Regarding: Texada Island east, Northeast Bay Aquaculture Application, revised application

Crown Lands File No 1414717
Internal Interest Identifier 962841
Disposition Transaction SID 933326
Feature Code FL98000100

a. Continuous Surface Support

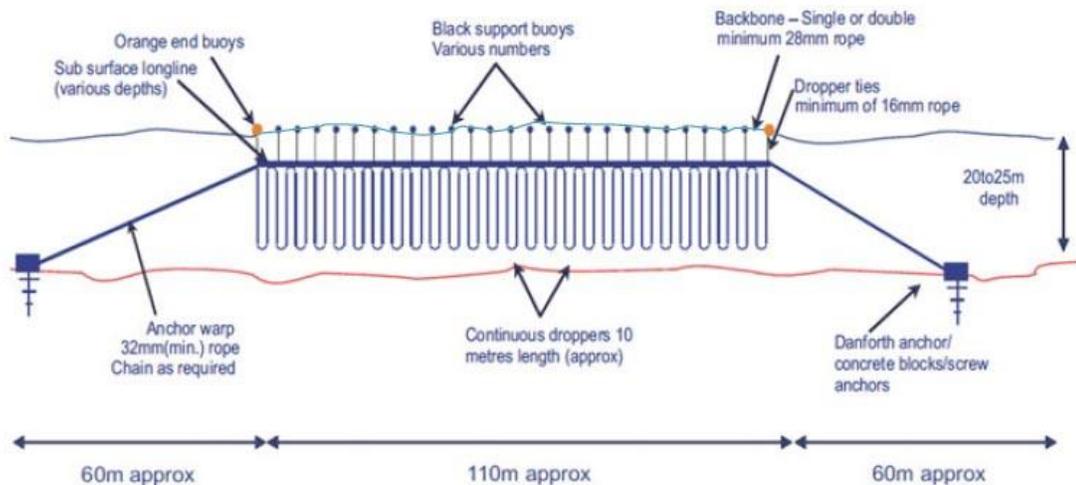
This system is unlike the revision, but there are some aspects to note. Contrary to an always changing and impossible neutrally buoyant approach, the only way to keep the extent of the longline parallel to the water surface [in ideal situations] is by a continuous line of highly buoyant floats. This of course works ideally but there are a proliferation of buoys and the system gets highly dynamic [moves sideways and up and down] because of the lower number of restraints. Note also that the extent of the 110-metre Longlines in this and the next example is much less than the revision's much longer 180 metres.

b. Intermittent Surface Support:

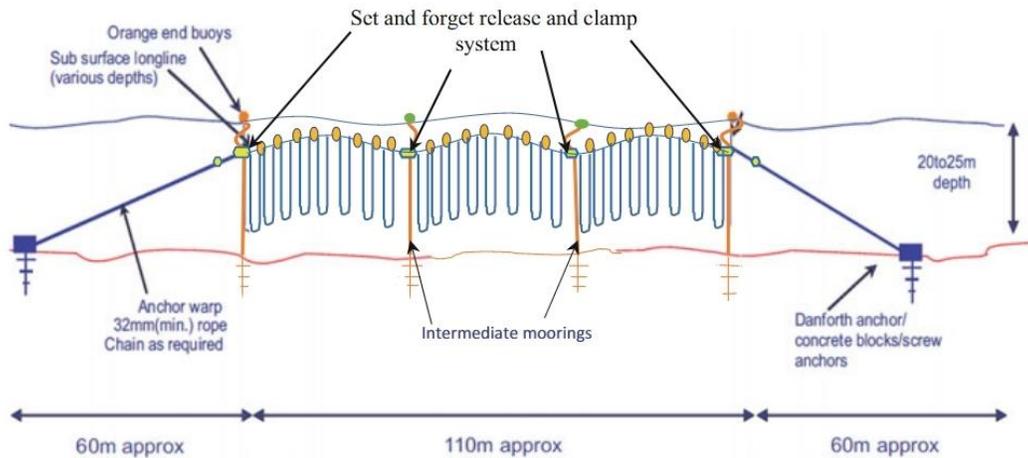
In this system, note almost twice the occurrence of surface buoys as well that each of them is restrained by bottom anchoring. Especially note the indication that this type of aquaculture is not neutrally buoyant but will arch up to the surface when unloaded and when ready for harvest will drape down. Note that when there are surface waves that reach even a fraction of the 5 metre depth of the aquaculture operation, surfacing will occur. This does not take into account storm events. Furthermore, there is an ominous subsurface presence of large submersed buoys with continuous substantial upward floatation forces. Have any of these been accounted for in public safety? Are there minimum requirements for this situation? We are not away that any have been stated or required.

Just think of the implications for kayaks, SUPs, swimmers and their safety in this situation. These craft and their owners are in the water as well as on it—especially SUPs. Just think of the propeller entanglement concerns of transiting motor vessels in storm conditions.
